# **FIRE SAFETY INSPECTION REPORT**

**APS KNIT COMPOSITE LTD.**

**ACCORD ID: 12359**

November 3, 2015

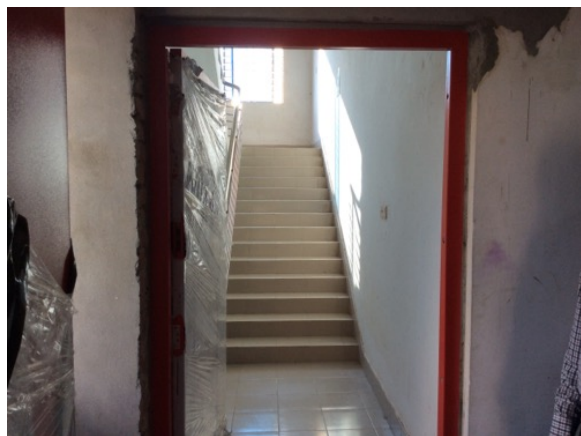
| F-11 | Egress | Collapsible gates are provided at exit discharge. | Replace all gates and sliding doors along the means of egress with side-hinged, swinging egress doors in accordance with ACCORD standard 6.8.1. | Within 1 month |
